## ANN ARBOR HISTORIC DISTRICT COMMISSION

### Staff Report

**ADDRESS:** 507 Second Street, Application Number HDC21-296

**REPORT DATE:** October 14, 2021

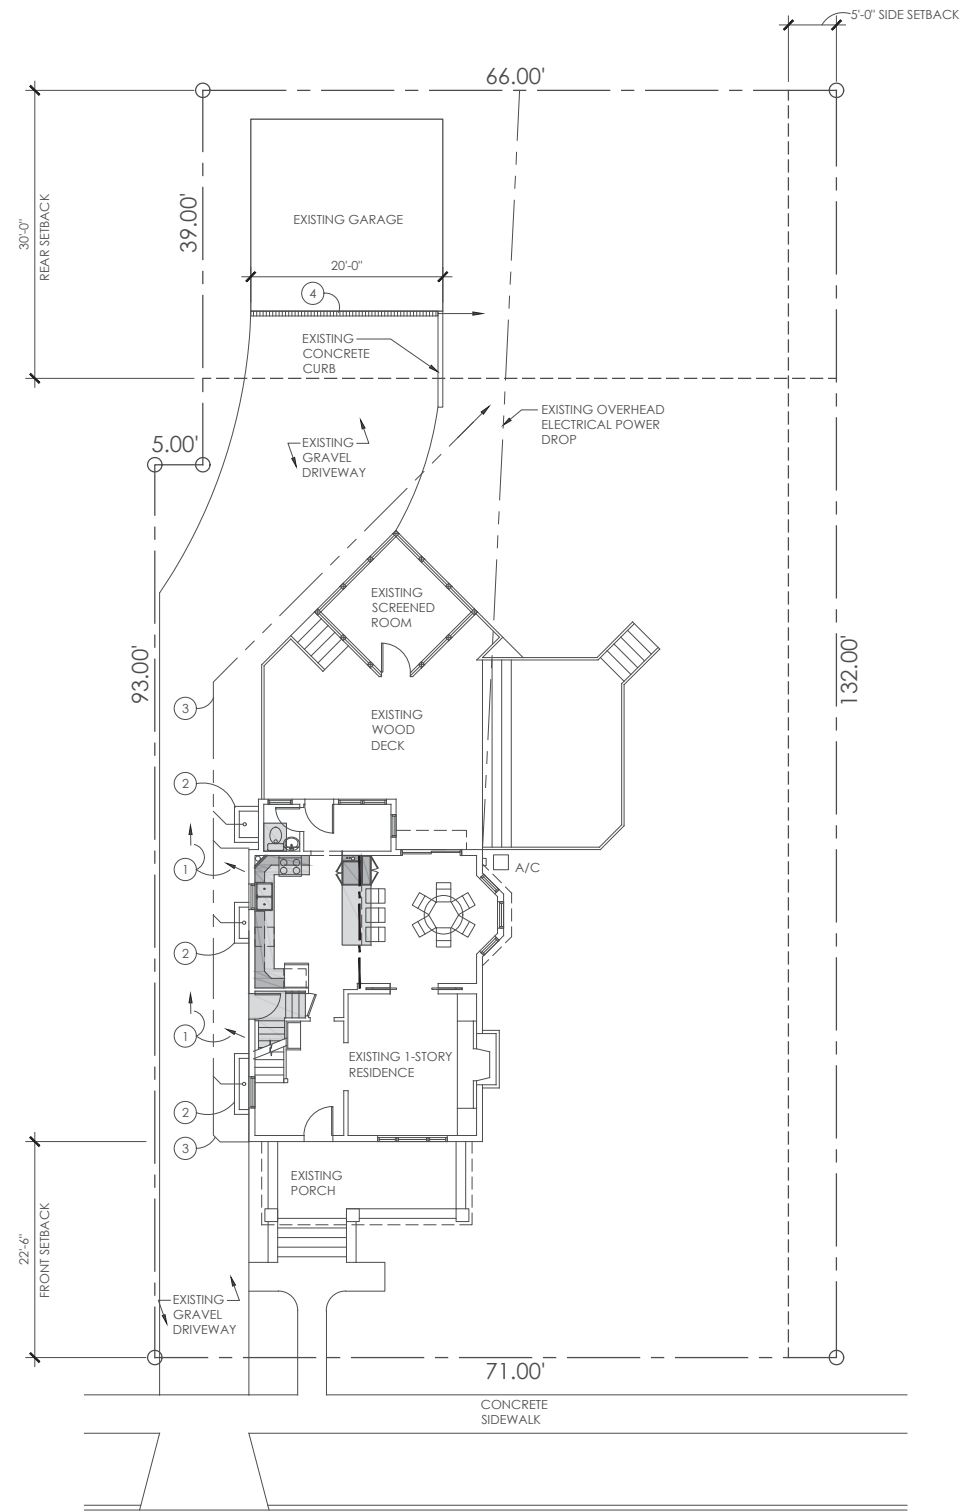
REPLACE WINDOW WITH A LARGER EGRESS WINDOW FOR A BEDROOM IN THE UPPER LEVEL (SEE 3/A3.1)

INSTALL NEW PATIO DOOR WITH SMALL ROOF ABOVE (SEE ELEVATION 3/A3.1)

REMOVE BRICK CHIMNEY ON BACK OF HOUSE (SEE ELEVATION 3/A3.1)

REPLACE WINDOW WITH A LARGER EGRESS WINDOW FOR A BEDROOM IN THE UPPER LEVEL (SEE 3/A3.1)

ADD NEW EAST-FACING WINDOW FOR NEW BATHROOM

REPLACE CONCRETE BLOCK WINDOW-WELL SURROUND ON THE NORTH SIDE OF THE HOUSE WITH NEW SPLIT-FACE CONCRETE - SEE A1.1 FOR DIMENSIONS

## D3.1

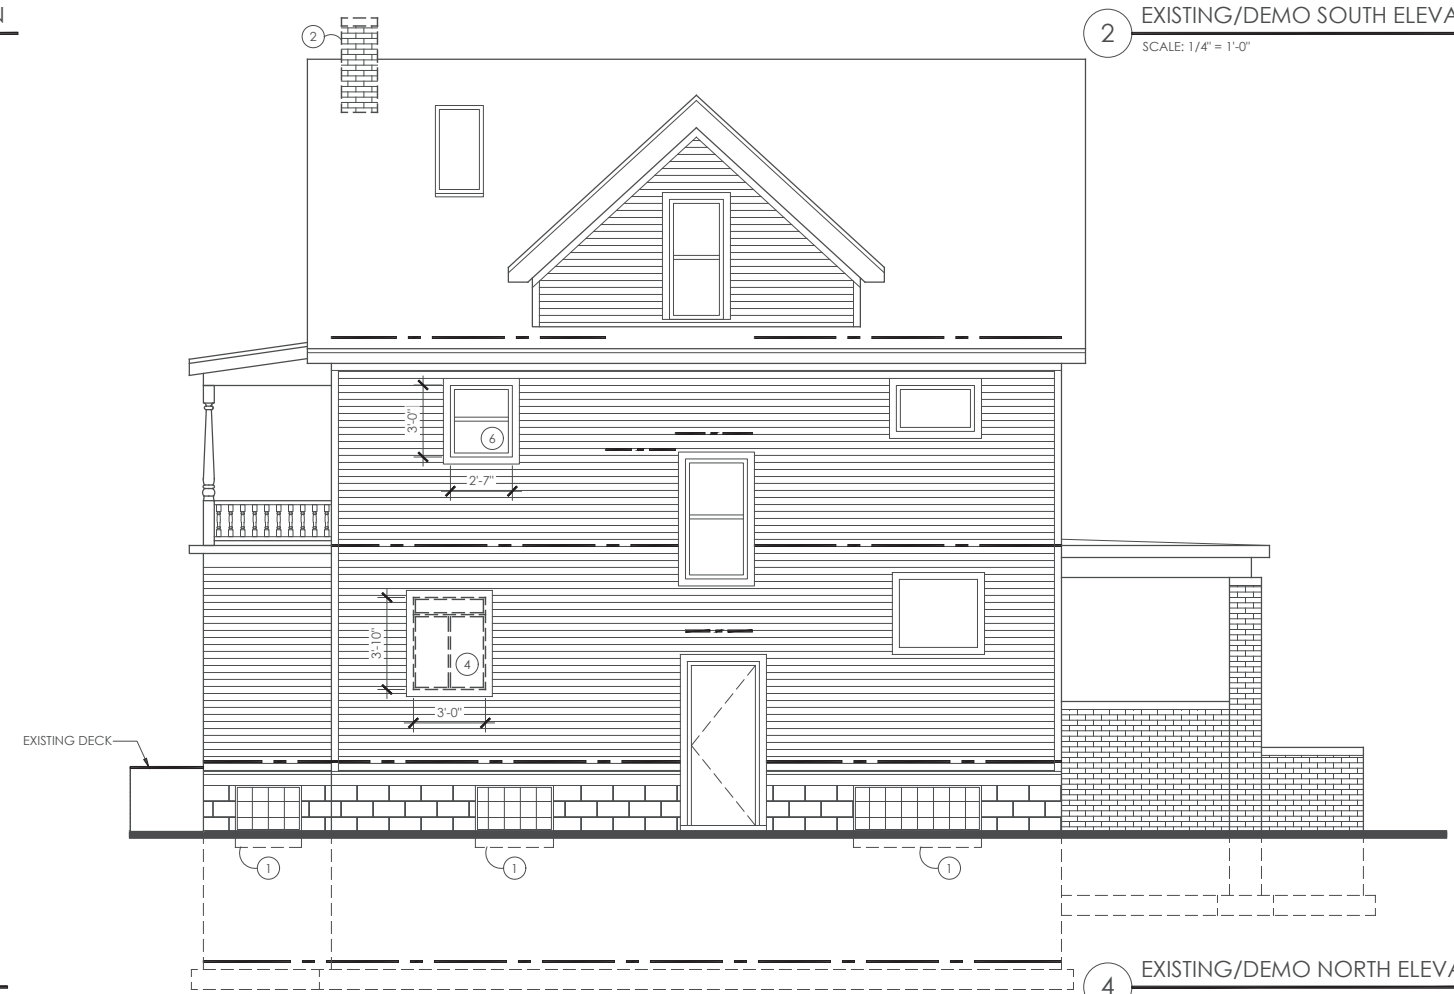
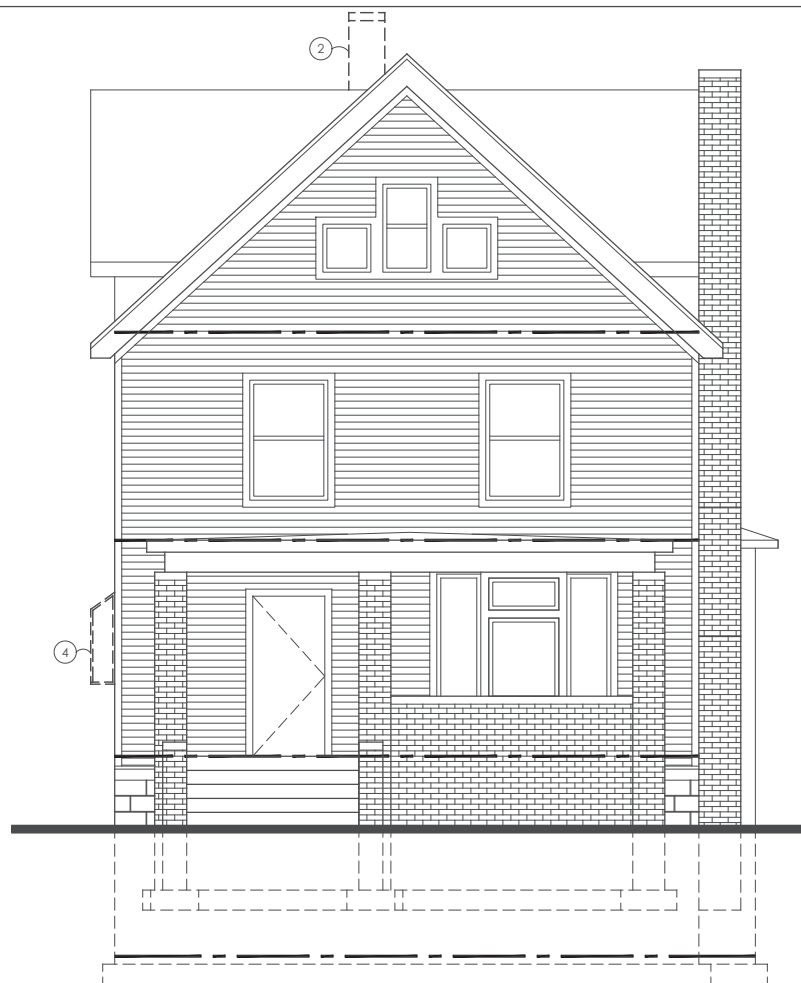
1 REMOVE EXISTING CONCRETE BASEMENT WINDOW WELL AND REPLACE WITH NEW - SEE SHEET A2.1

2 REMOVE EXISTING BRICK CHIMNEY TO ACCOMMODATE NEW CONSTRUCTION.

3 REMOVE PATIO DOOR AND EXTERIOR WALL TO ACCOMMODATE INSTALLATION OF NEW HEADER AND LARGER DOOR.

4 REMOVE EXISTING TERRARIUM WINDOW. SEE A2.1 FOR NEW WINDOW.

5 REMOVE EXISTING WINDOW AND EXTERIOR WALL TO ACCOMMODATE NEW EGRESS WINDOW.

6 EXISTING WINDOW TO REMAIN - REMOVE GLASS ONLY TO INSTALL NEW TEMPERED SAFETY GLASS

7 REMOVE EXISTING SIDING TO ACCOMMODATE NEW SHED ROOF CONSTRUCTION.

8 REMOVE EXTERIOR WALL TO INSTALL NEW BATHROOM WINDOW AND HEADER.

A3.1

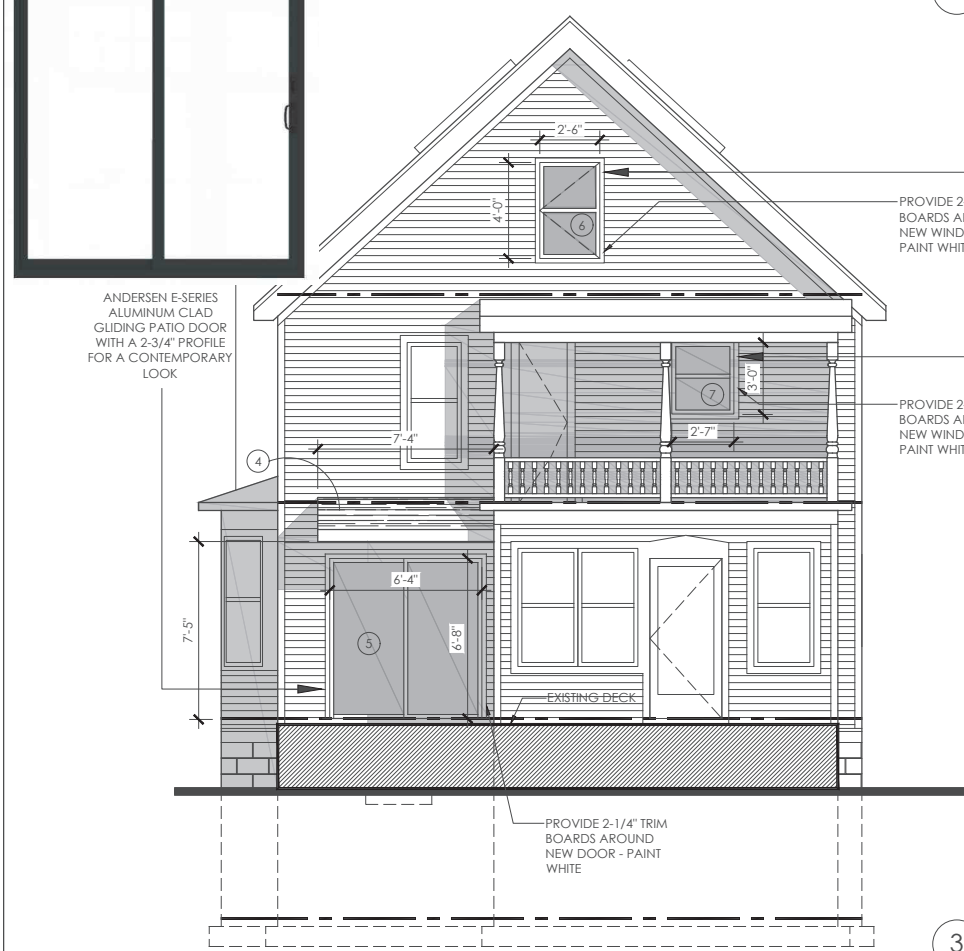
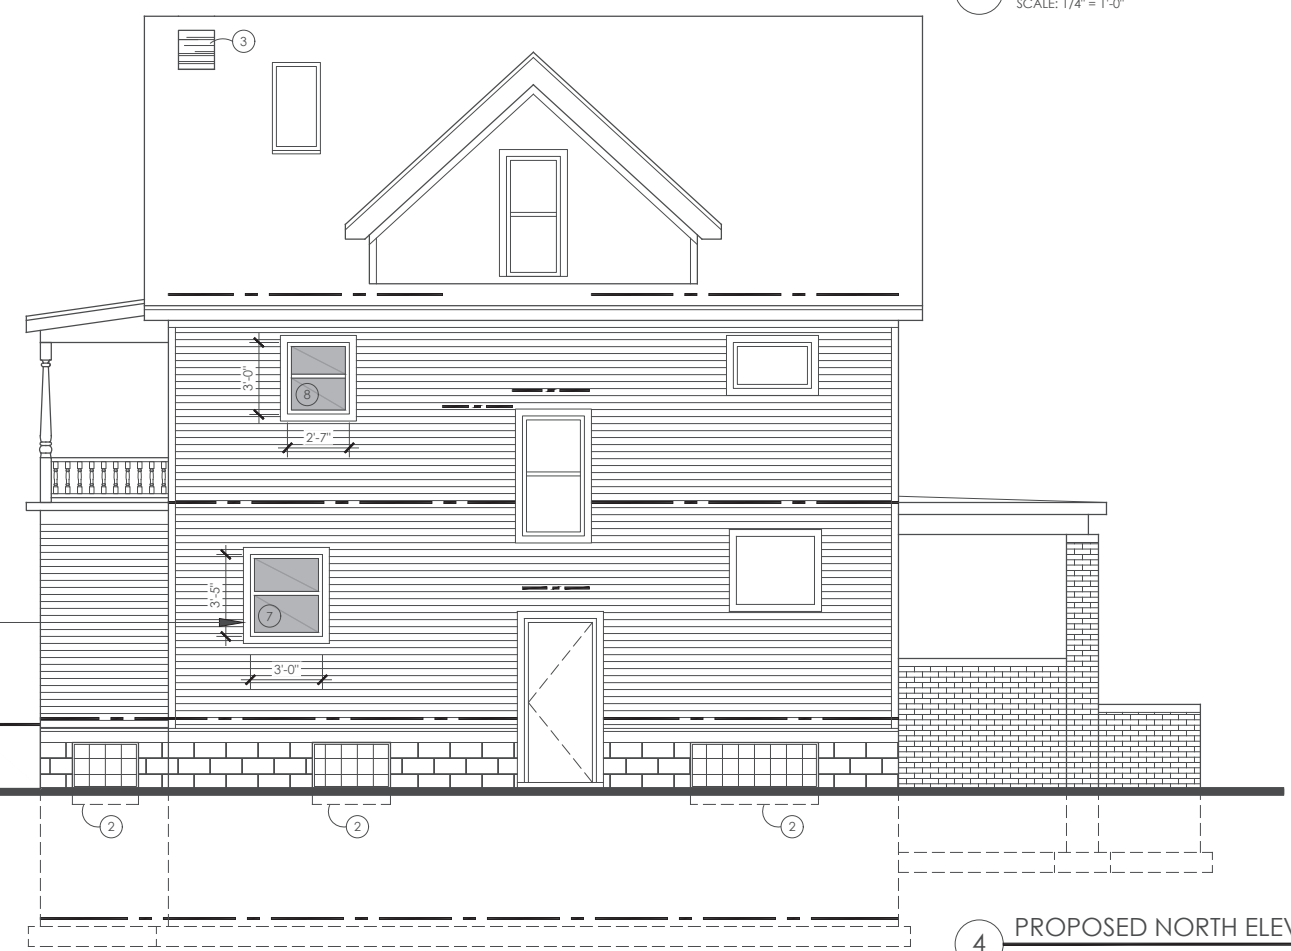
3. Replace terrarium window with a double-hung window: This is appropriate.
4. Replace patio door and add shed roof: A slightly wider patio door will have no adverse impact on the rear elevation of the house. The proposed shed roof is simple and will protect the patio door opening.

5. New window in a new opening on the second floor east elevation: This window is under a second floor porch roof. Proposed is tempered frosted glass. This would not be appropriate in a historic opening, but staff believes it is acceptable in this new opening in an inconspicuous location.

6. Replace window glass with safety glass: This is appropriate since the existing sash will be used, and the glass will be clear.
7. Replace east attic window with a larger egress window: The existing window is 3'8" x 1'10" double-hung and the proposed is 4' x 2'6" casement with a false muntin that meets egress requirements. The new trim is narrower than the existing historic trim. Staff believes this is acceptable since the window faces the back and meets egress requirements.

8. Remove east chimney: This is a secondary chimney, not the character-defining one visible from the street. Removing it will have no negative effects on the historic structure.
9. The proposed work will have minimal negative effects on the historic structure and materials while improving livability, safety, and drainage. The work meets the Secretary of the Interior's Standards and staff recommends approval of the application.
